# 2305 MONTEVALLO ROAD PROPOSAL

# Planning Commission feedback

# Current proposal

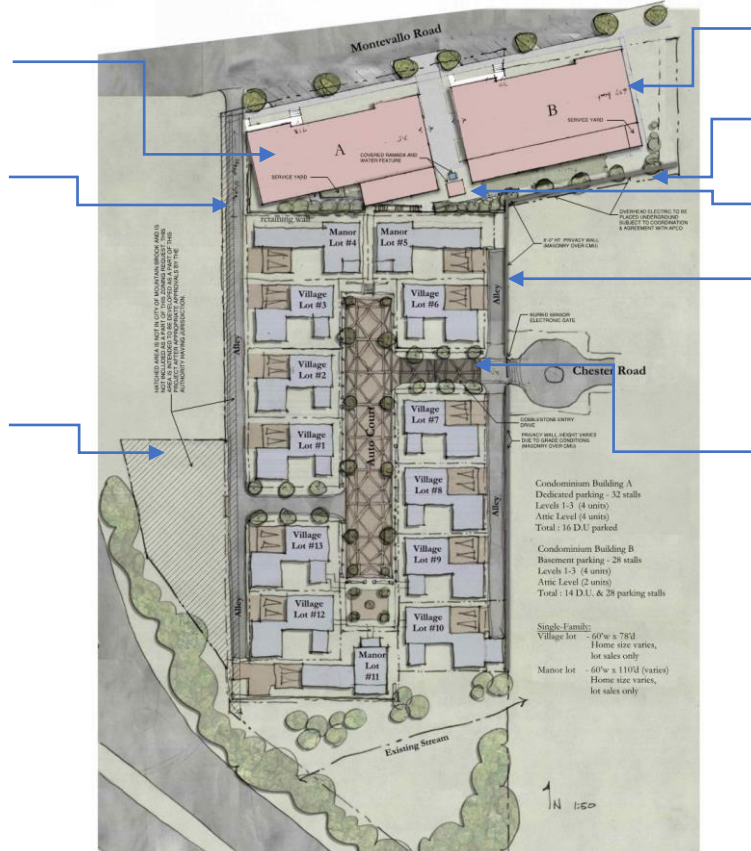
3. Address the parking shortage for the project. As submitted, the parking shown does not meet the Res G requirements for off-street parking.

5. Investigate primary access from Montevallo Road and/or provide explanation why the ingress and egress for the Single-family portion of the project must occur at Chester Road.

CONDO BUILDINGS PARKED AT 2 STALLS / UNIT

IMPROVEMENTS TO HOMEWOOD ALLEY APPROVED BY HOMEWOOD CITY COUNCIL ON SEPT. 26TH

THIS AREA REMOVED FROM PROPOSAL

UNIT COUNT REDUCED AND BUILDING MASSING MODIFIED

UNDERGROUND UTILITIES AND INCREASED LANDSCAPE BUFFER

REMOVED POOL AMENITY, REPLACED WITH SMALL GAZEBO AND WATER FEATURE

PRIVACY WALL INCREASED TO 8'-0" HEIGHT NORTH OF CHESTER ROAD R.O.W. TO NORTHEAST PROPERTY LINE.

AUTOMATIC GATE AND COBBLESTONE ENTRY DRIVE ADDED TO ENCOURAGE USE OF MONTEVALLO ROAD ACCESS

# Traffic Impacts to Chester Road

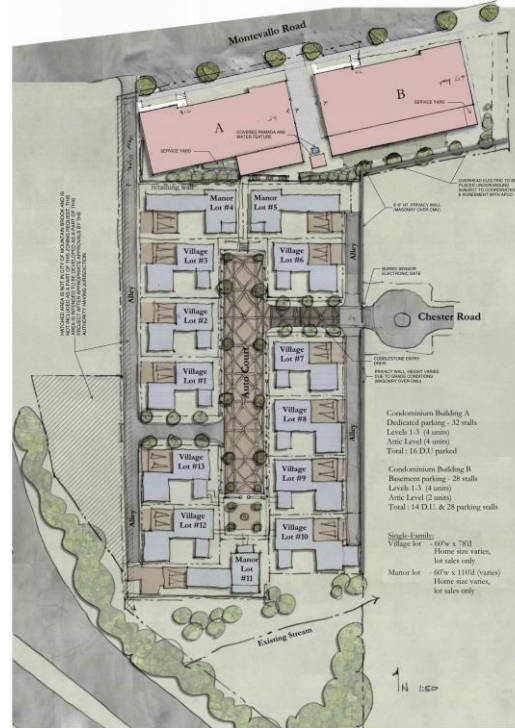
1. Concerns over traffic added to Chester Road
2. Concerns about the scale and design of Condo B

THIS IS A "BY RIGHT" PROPOSAL THAT WOULD ADD 8 RESIDENCE B LOTS + THE HOMEWOOD PARCEL FOR A TOTAL OF 9 HOMES TO CHESTER ROAD. THIS ADDS 110 CAR TRIPS TO CHESTER ROAD DAILY. IT WOULD ALSO REQUIRE ALL CONSTRUCTION TRAFFIC TO ACCESS THE SITE THROUGH CHESTER ROAD.

THIS IS THE CURRENT PROPOSAL THAT WOULD ADD 13 RESIDENTIAL LOTS + THE HOMEWOOD PARCEL FOR A TOTAL OF 14 HOMES TO CHESTER ROAD. THIS ADDS 99 CAR TRIPS TO CHESTER ROAD DAILY. THE REMAINDER OF THE CAR TRIPS EXIT ONTO MONTEVALLO ROAD. THIS SECONDARY ACCESS ALSO PROVIDE SERVICE AND CONSTRUCTION ACCESS, FURTHER ALLEVIATING TRAFFIC IMPACTS ON CHESTER ROAD.
